ROGERS CENTRAL KITCHEN HVAC PROJECT

ADDENDUM #1

Date Issued: April 4th, 2025

ROGERS MS CENTRAL KITCHEN (B#24-025) ADDENDUM 1 SPECIFICATION NARRATIVE

1	SCALE	3
	NTS

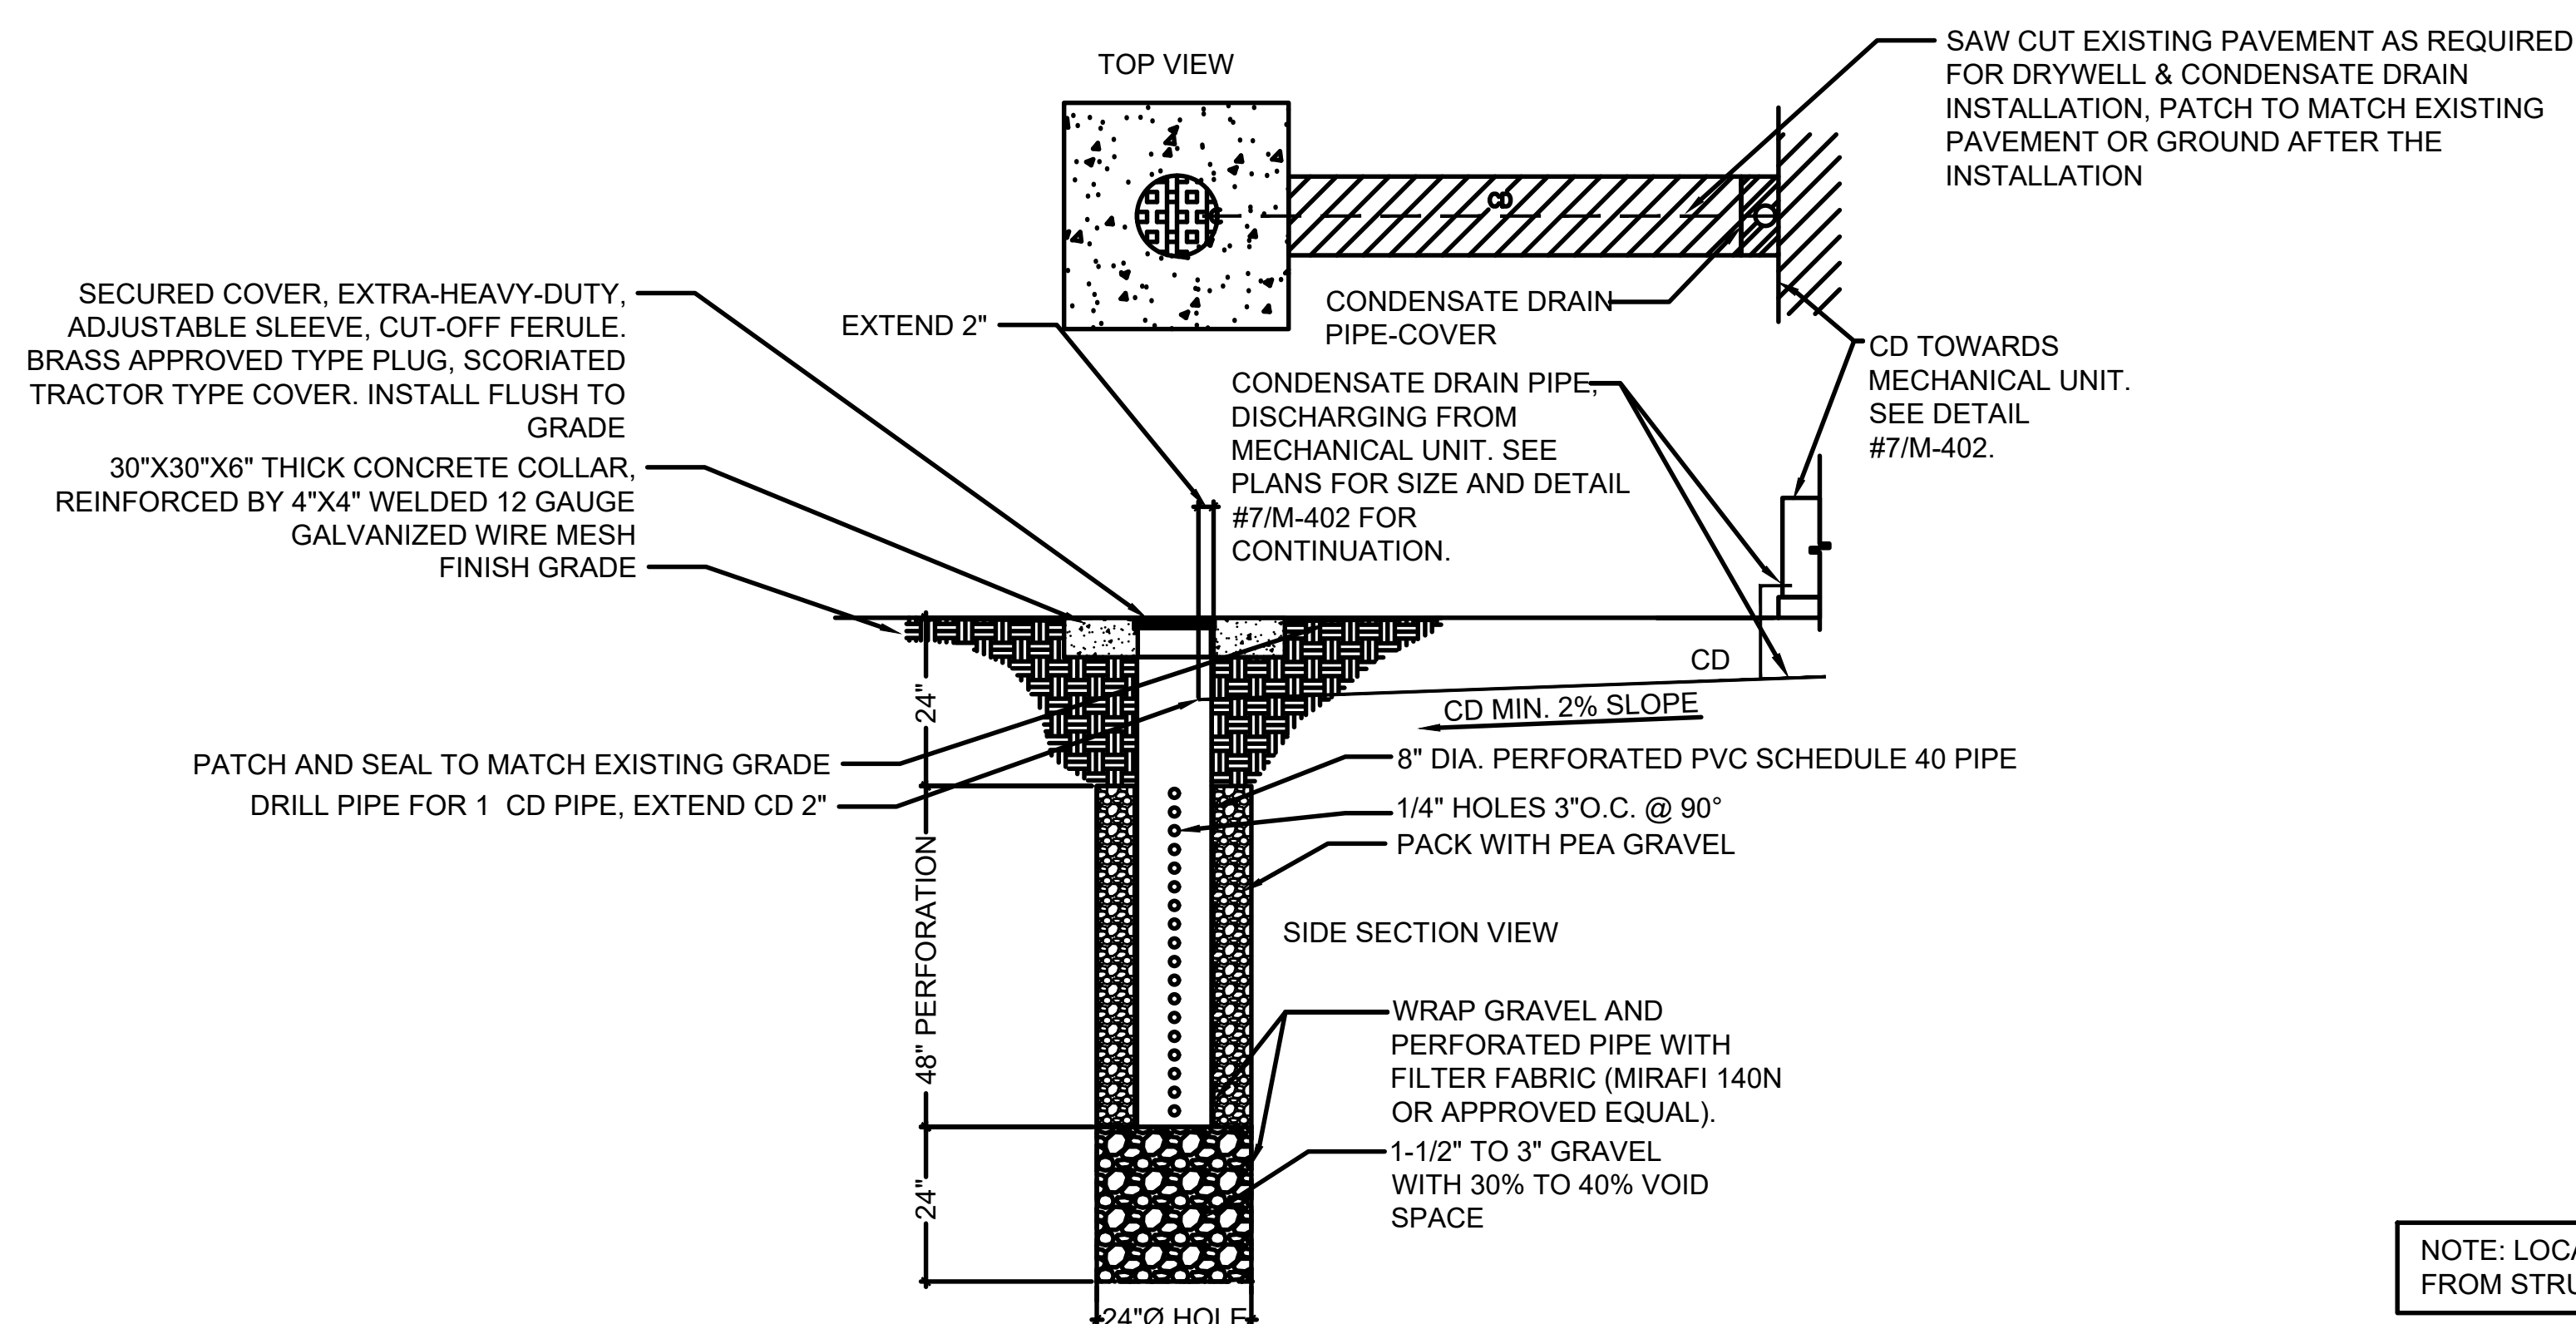
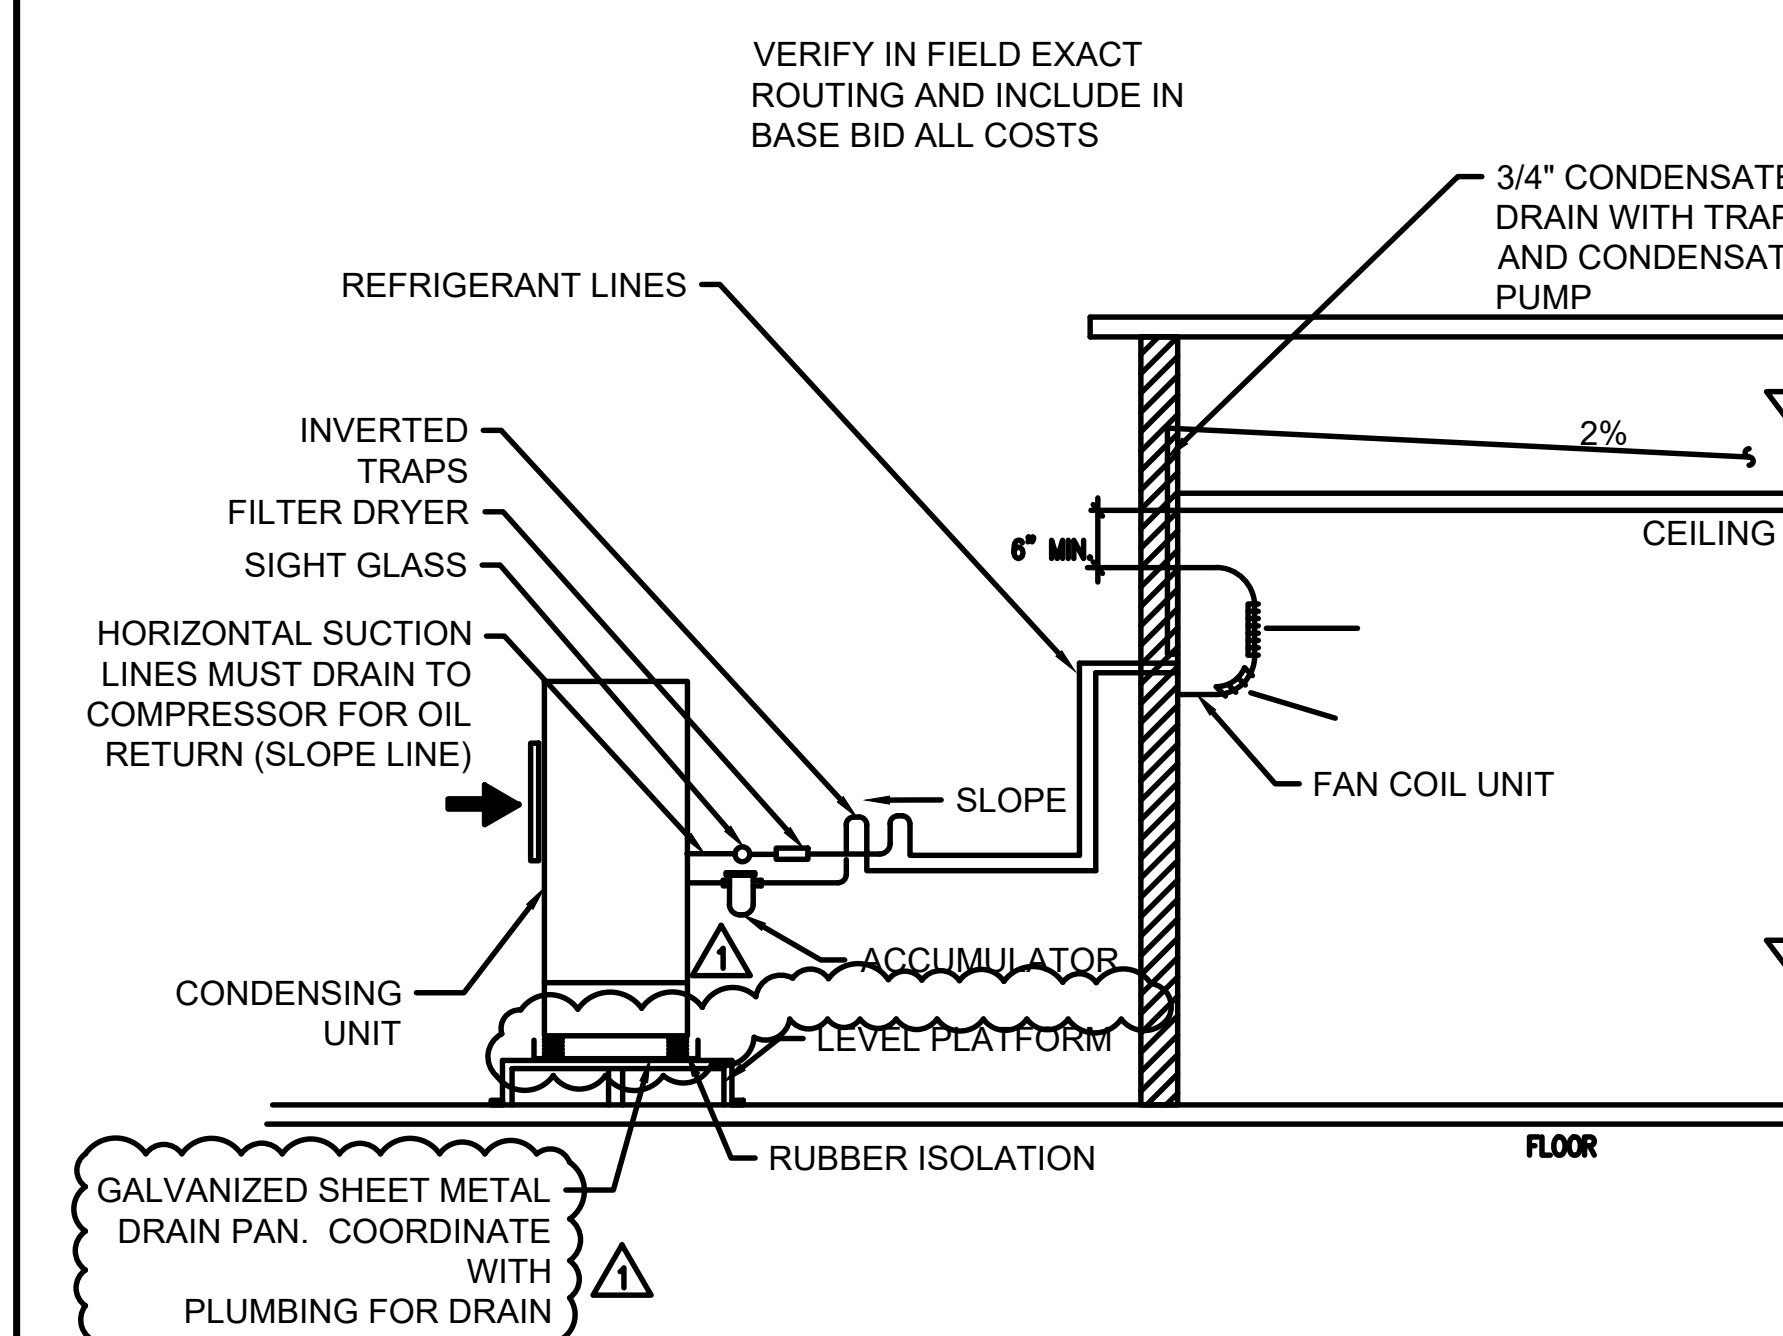
6. M-402 MECHANICAL DETAILS SHEET

- a) Revised Detail 1 – FCU Condensate Removal Detail so the CD slope is revised.
- b) Added Detail 4 - Condensate Drain to (E) Lav or Mop Sink.
- c) Revised Detail 6 - Outdoor Unit – CD Connection Detail so the draining method is simplified.
- d) Revised Detail 7 – Outdoor Unit Mounting Detail so the galvanized sheet metal pan is mounted directly to the concrete pad.

MECHANICAL FIRST FLOOR CONDENSATE PLAN

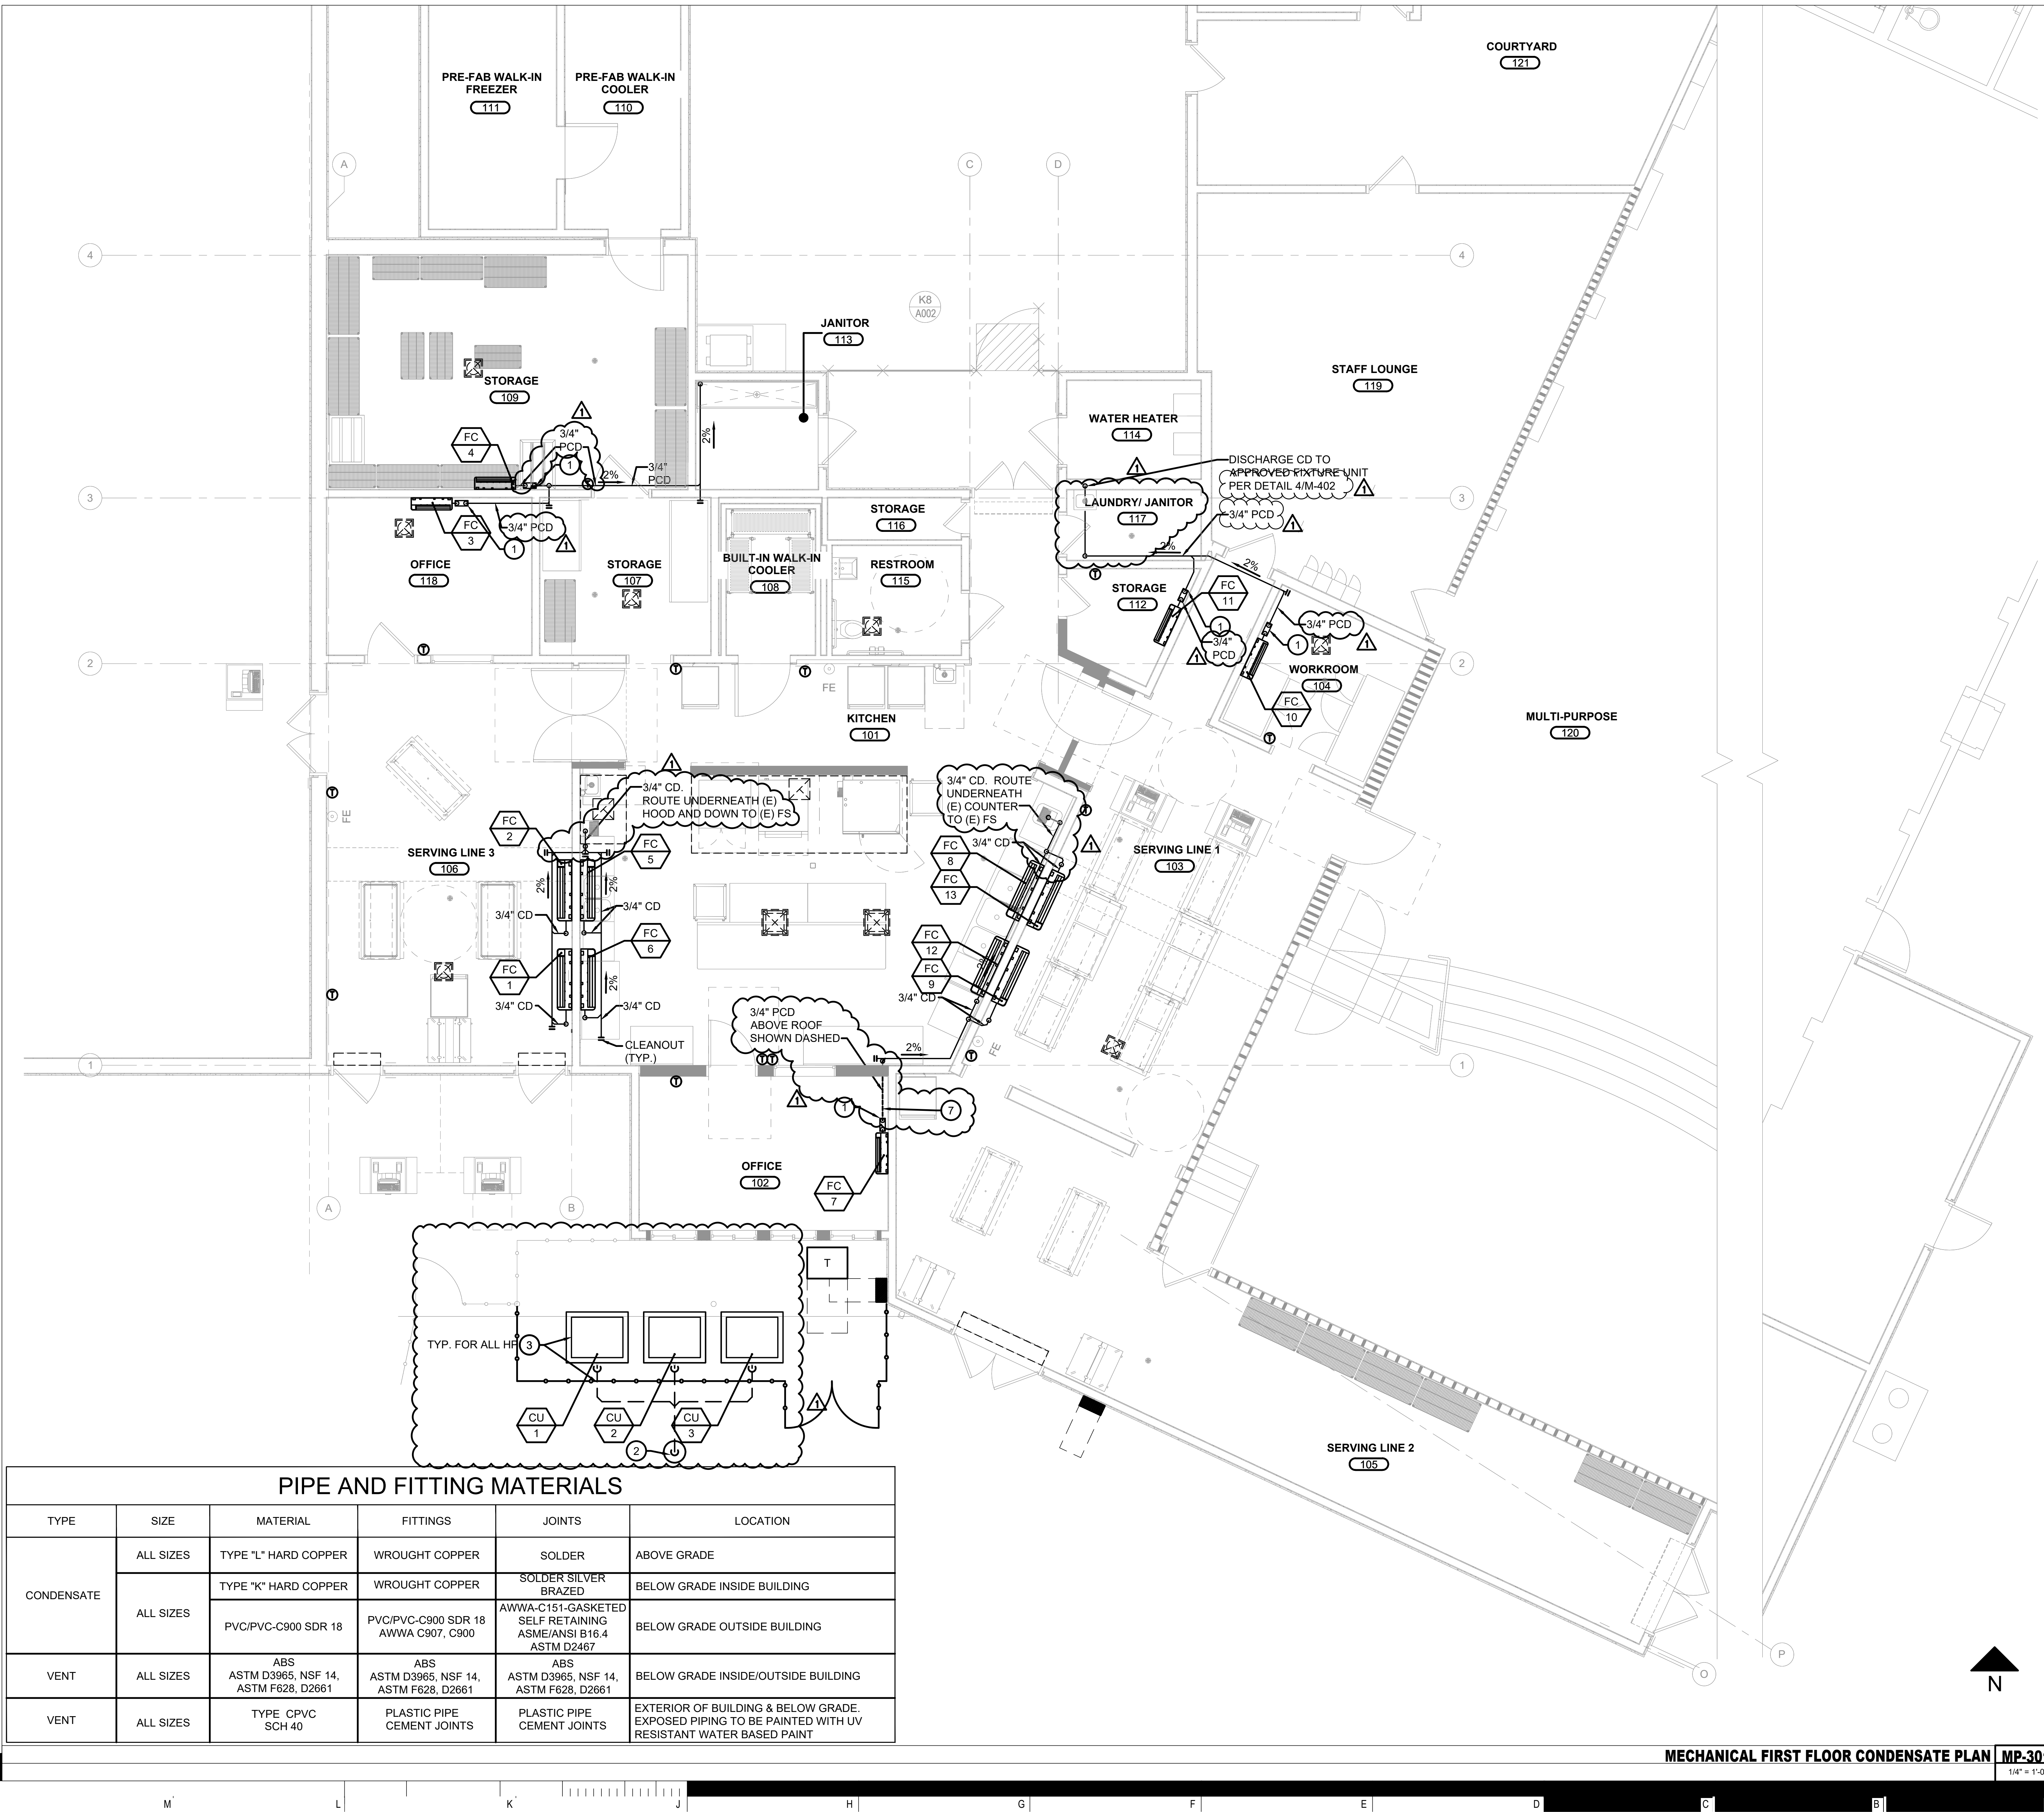
9. MP-301 MECHANICAL FIRST FLOOR CONDENSATE PLAN

- a. Added General Note 'B'.
- b. Revised Remodel Keynotes #1 and #3. Removed Remodel Keynotes #4, #5 and #6 and indicated them as "Not Used". Added Remodel Keynote #7.

- c. Revised location of outdoor CU units and method of drainage. Removed underground vents that were serving the CU's.
- d. Clarified Pumped Condensate (PCD) locations.
- e. Clarified routing of gravity drained condensate to the existing floor sinks in Kitchen 101.
- f. Clarified routing of pumped condensate from FC-7. This will require patching the existing roof and the existing clerestory window infill.
- g. Revised routing of condensate into sink tailpiece in Laundry/Janitor 117.
